CONSTRUCTION PLANS
FOR
**PONDEROSA AT
LORSON RANCH FILING NO. 3**
STREET/STORM SEWER AND UTILITY CONSTRUCTION PLANS

COVER SHEET
STREET/STORM SEWER
AND UTILITY PLANS

PUDSP-19-010

SHEET NUMBER C6.4

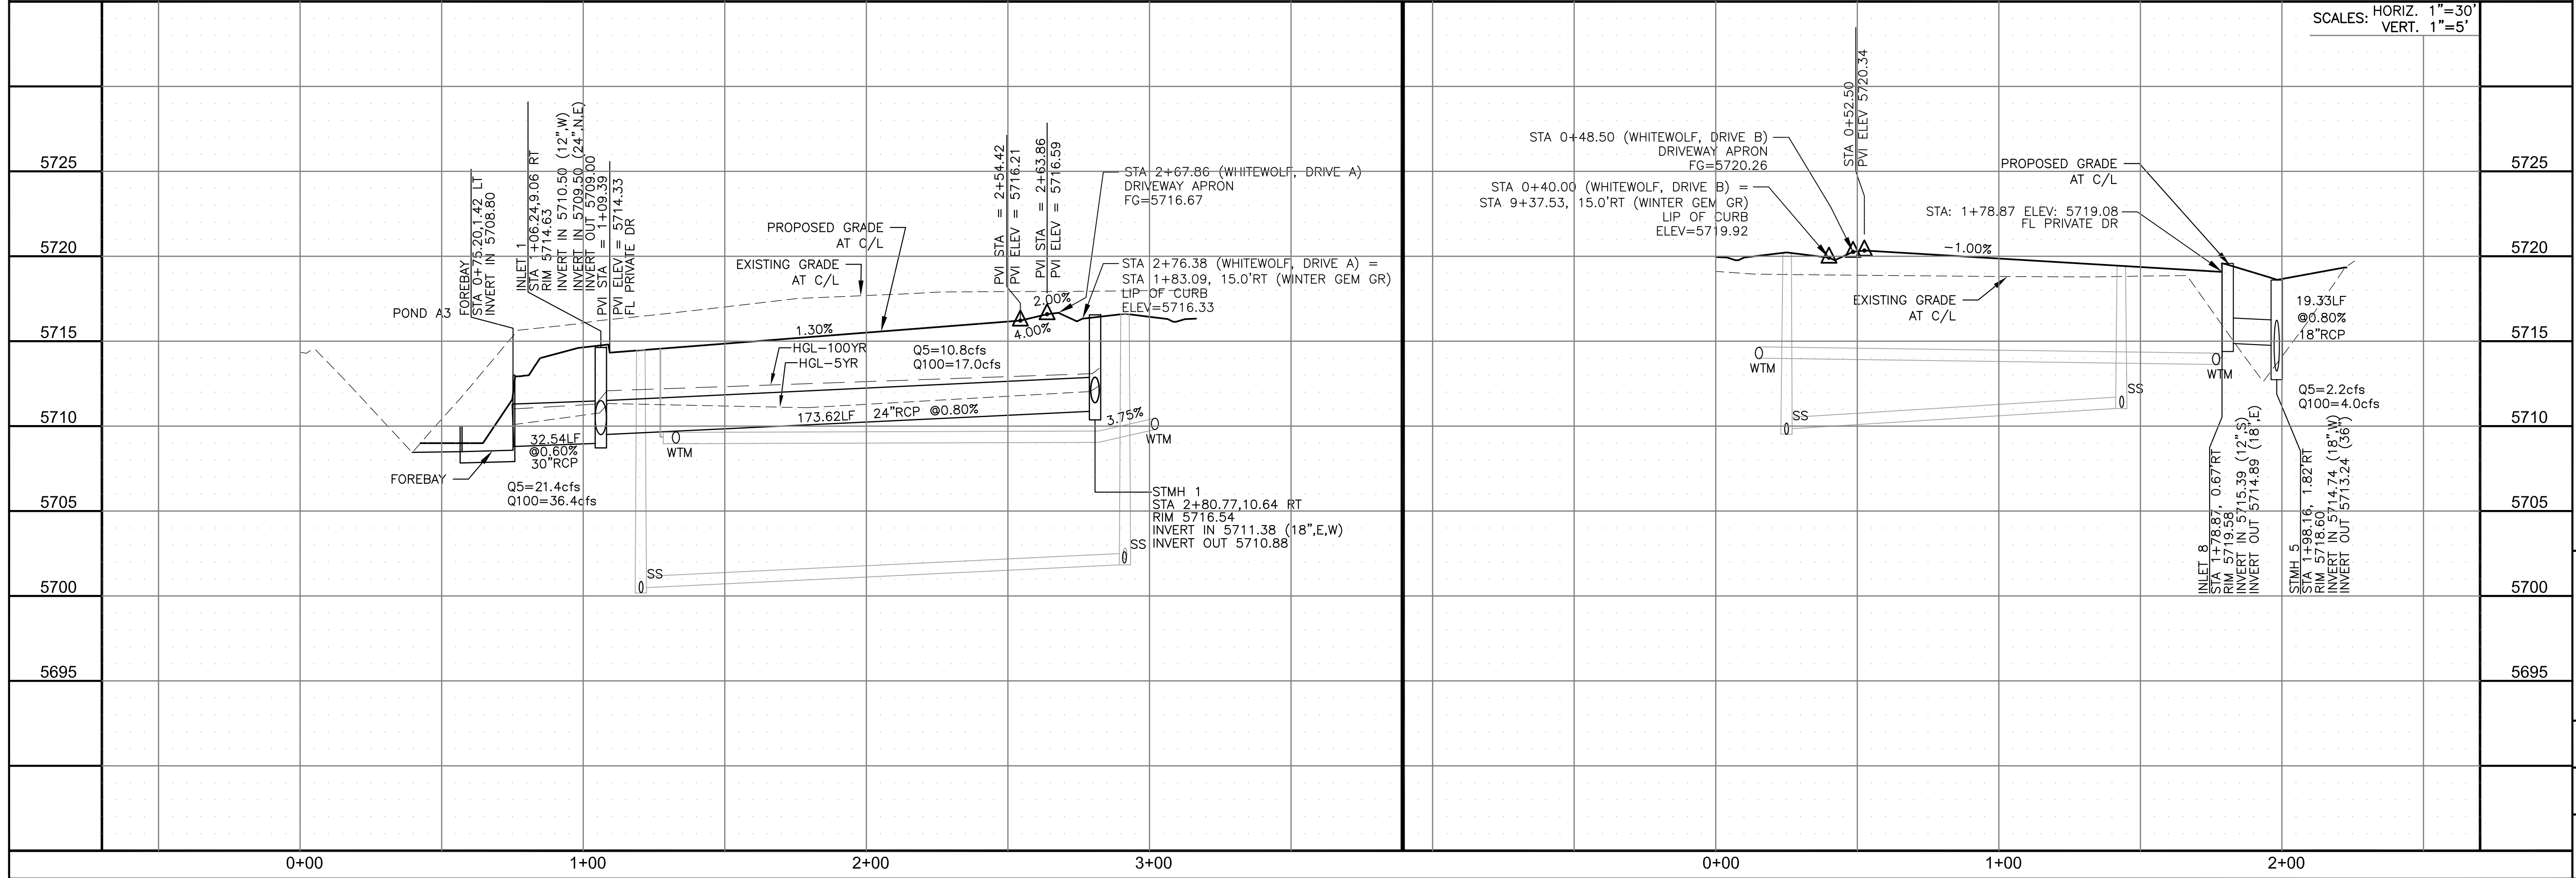
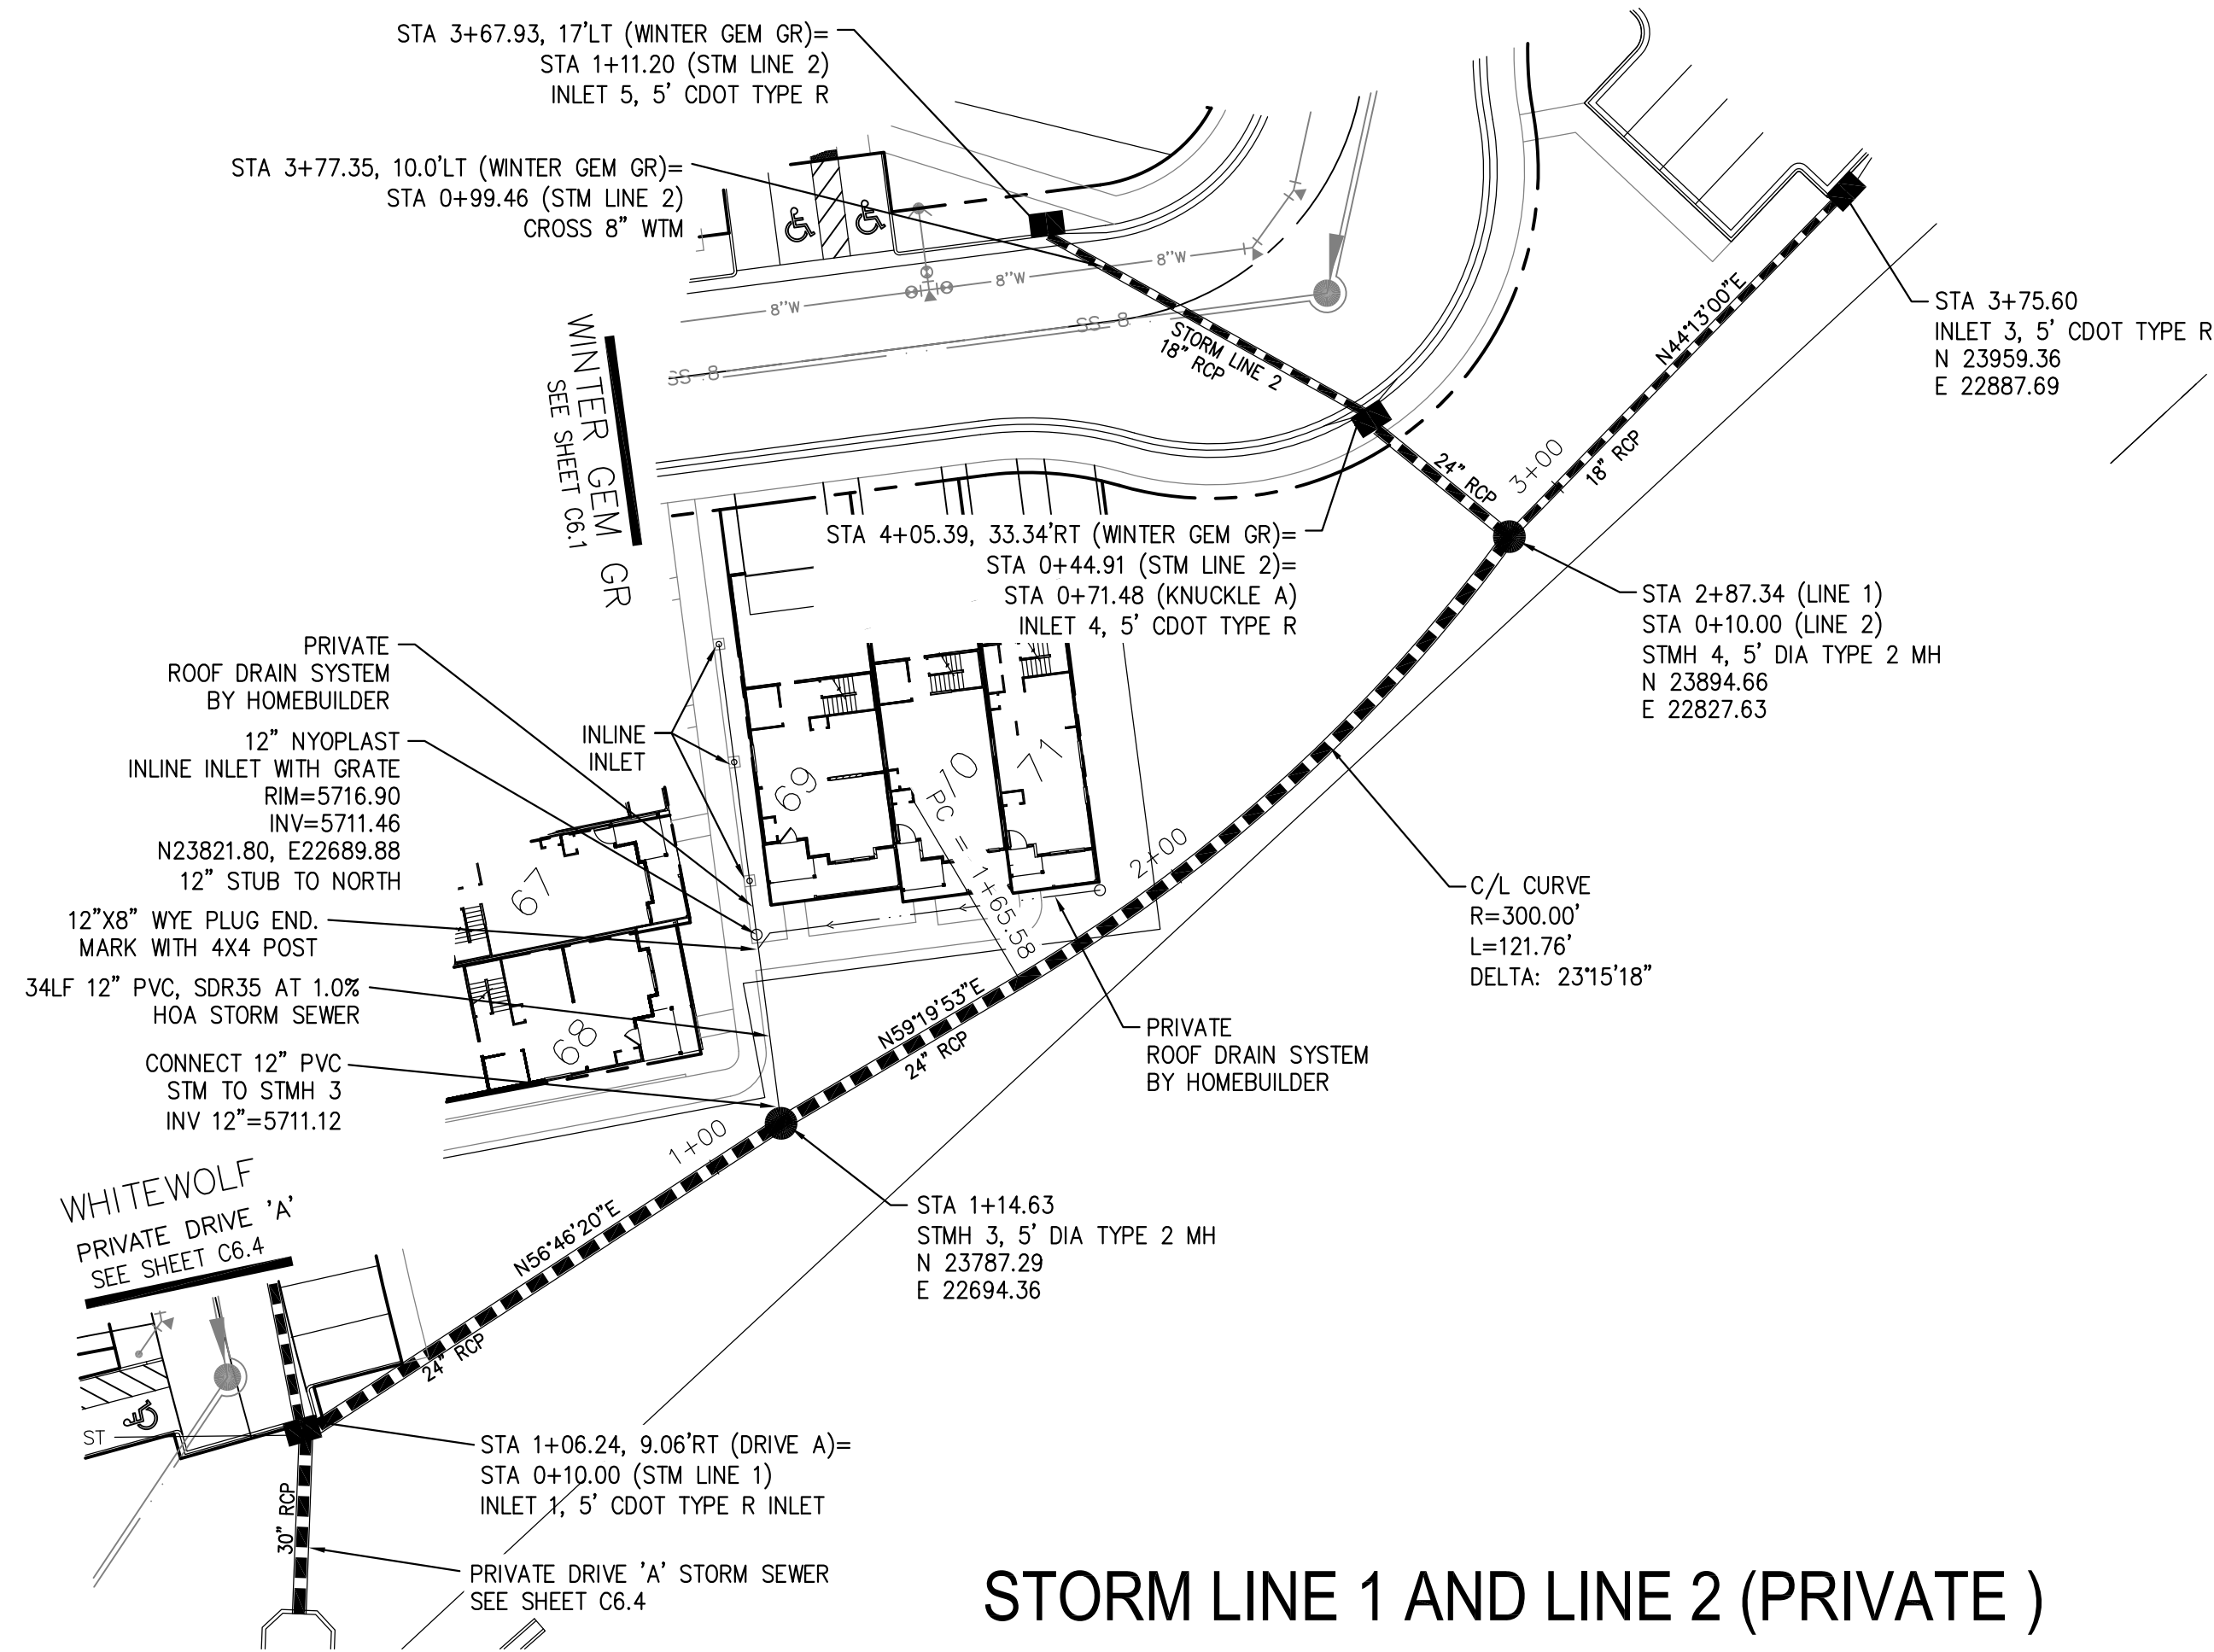
Update reference for pond design to the Final Grading and Erosion Control Plan

See comments on the GEC. Stormlines to be private

PEDESTRIAN RAMPS AT INTERSECTIONS (ECM SD 2-40)
NO SCALE

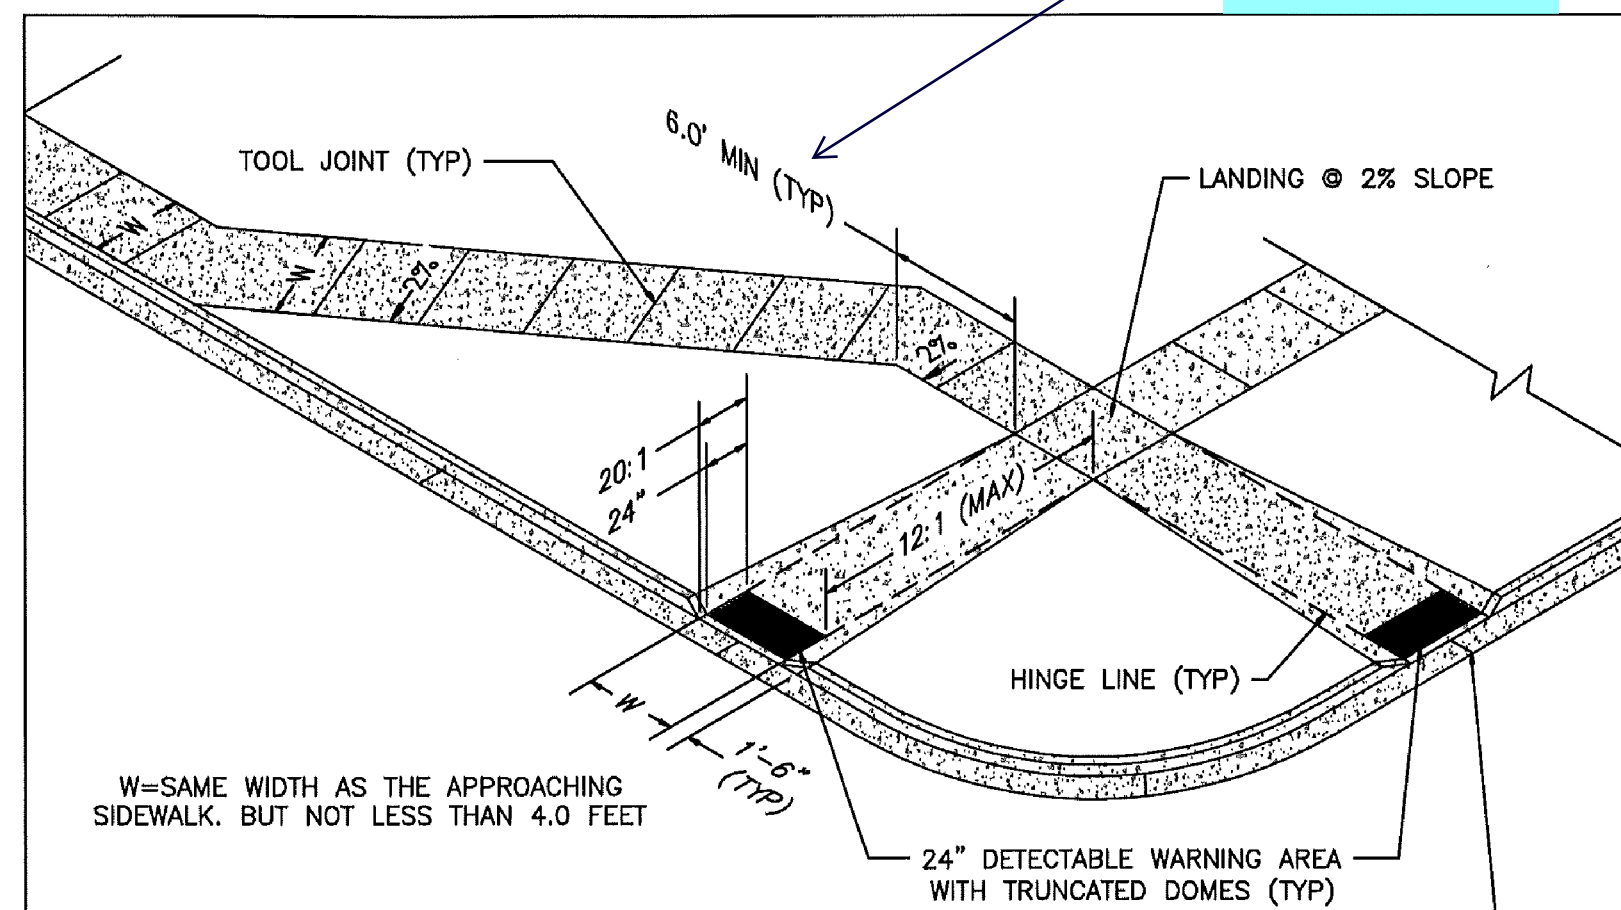
Replace with the latest version of the detail per resolution 20-222

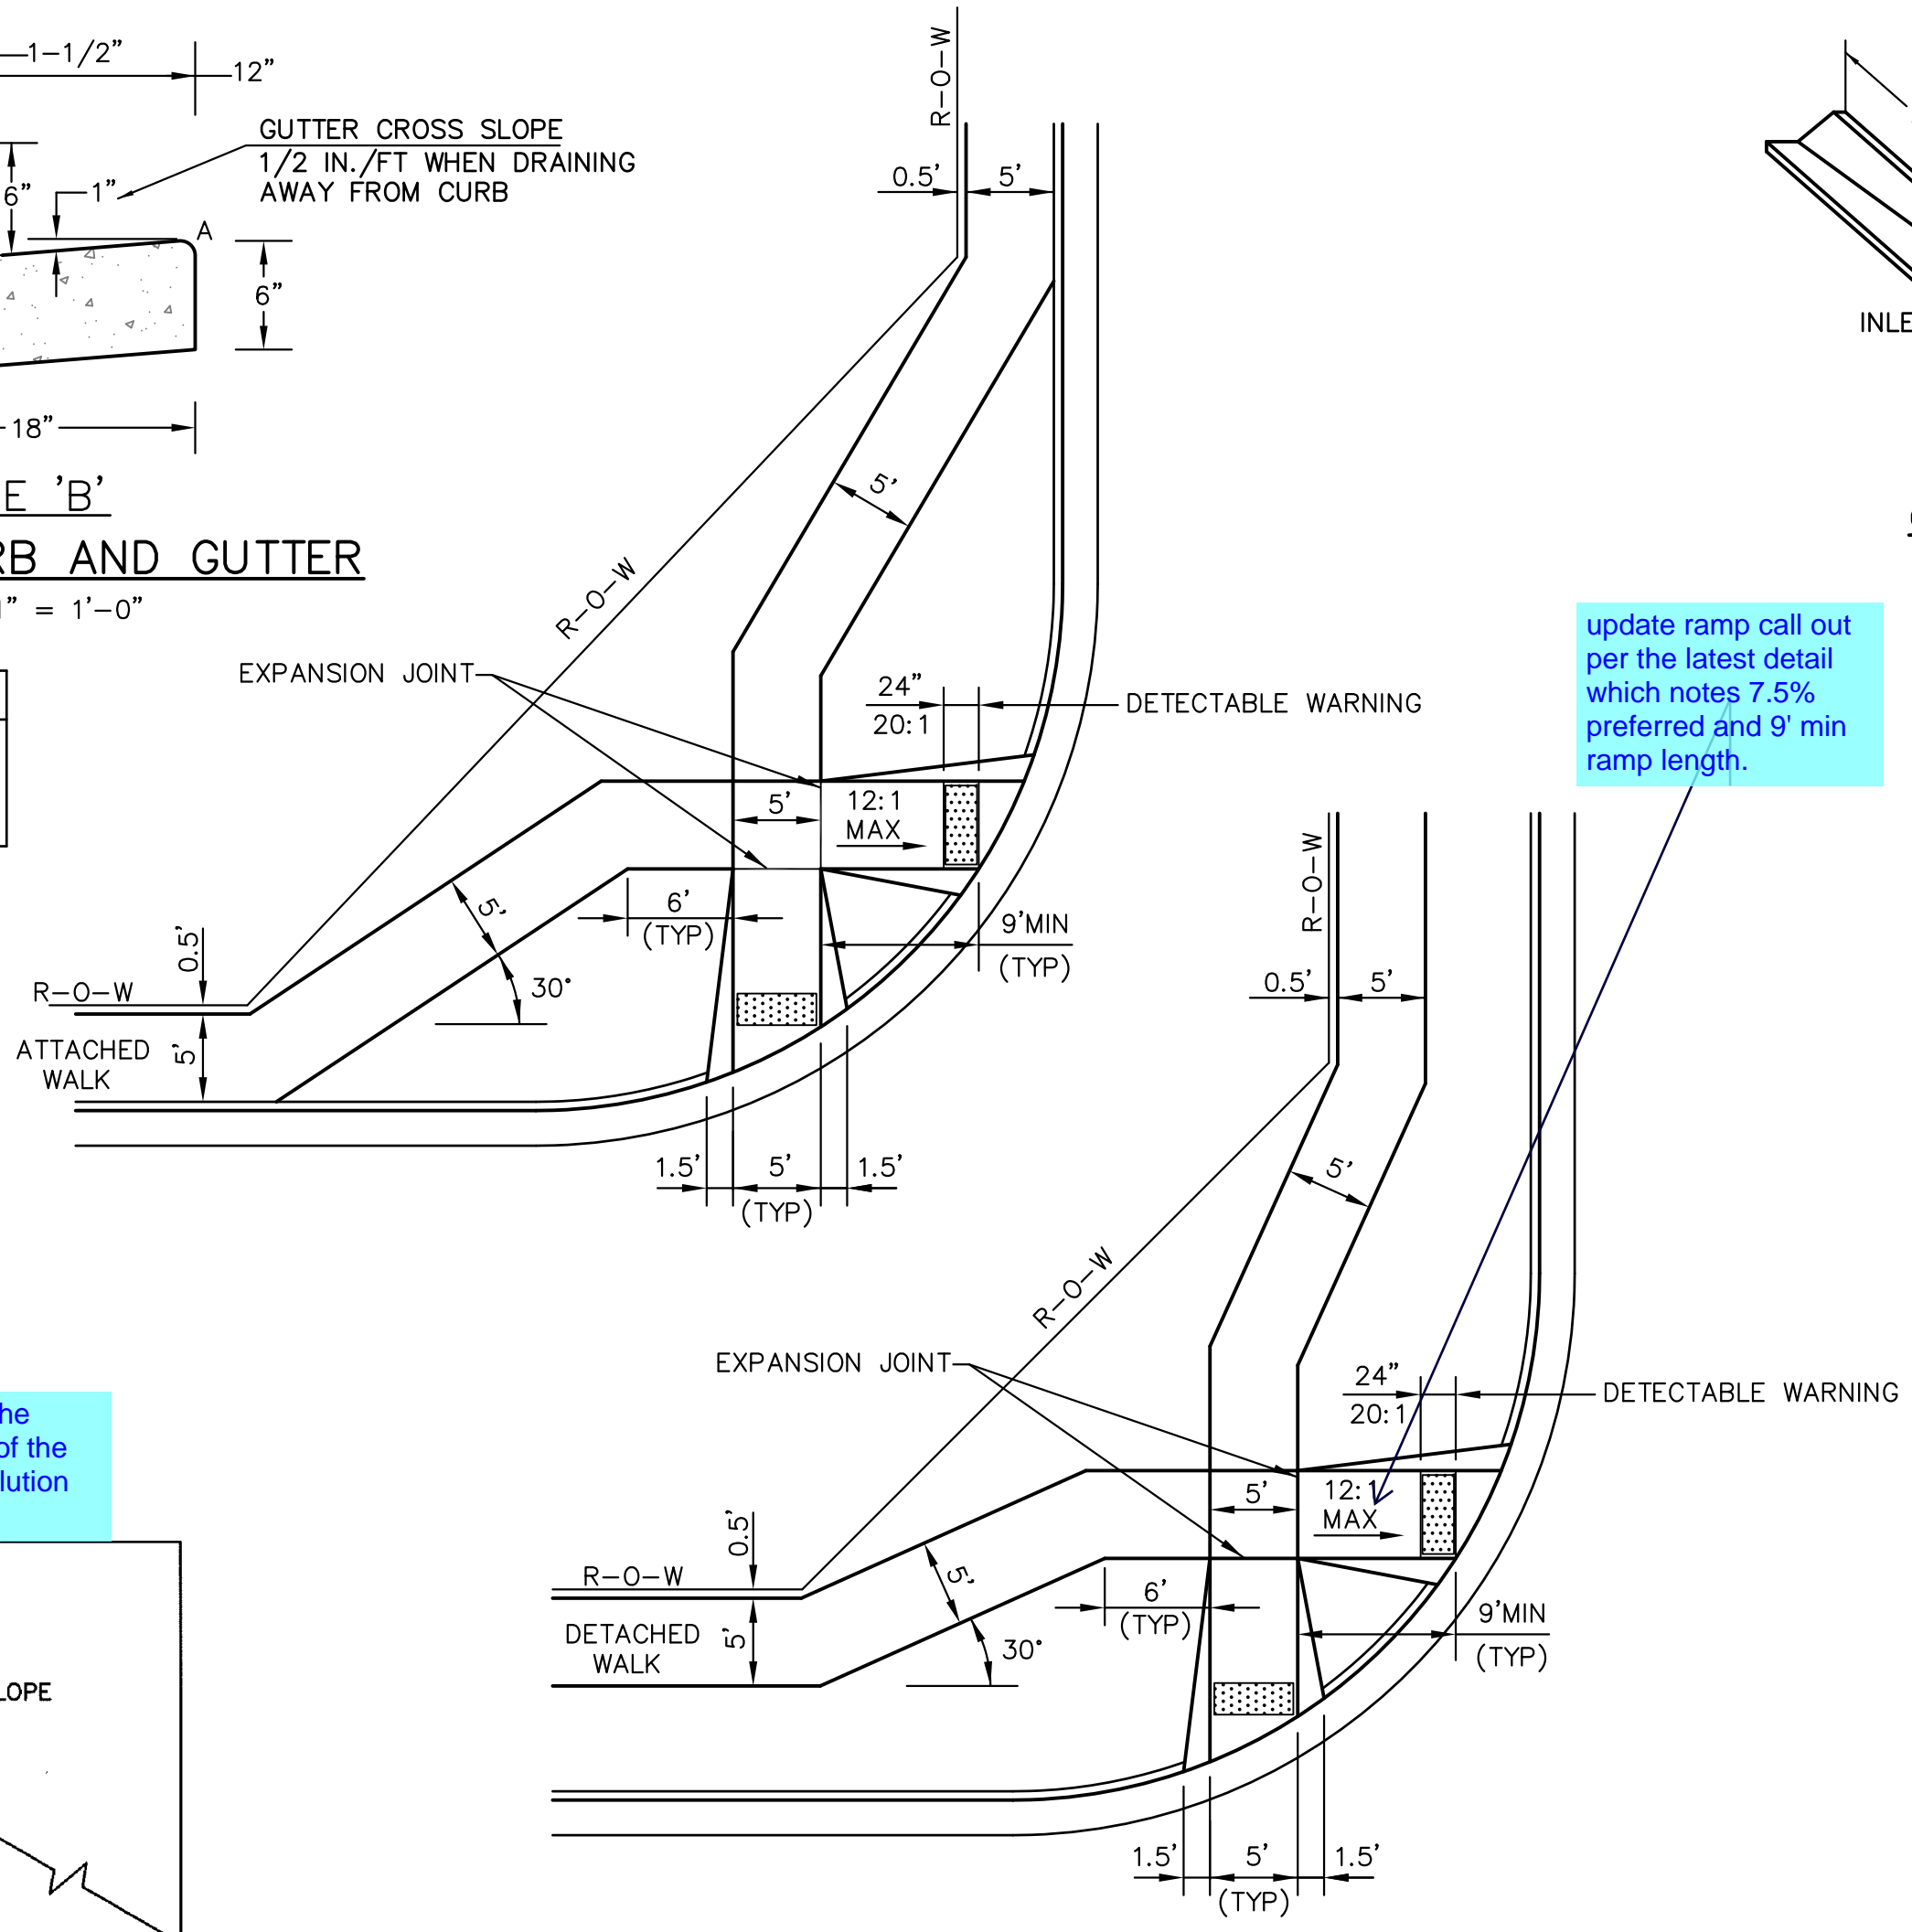
update ramp call out per the latest detail which notes 7.5% preferred and 9' min ramp length.
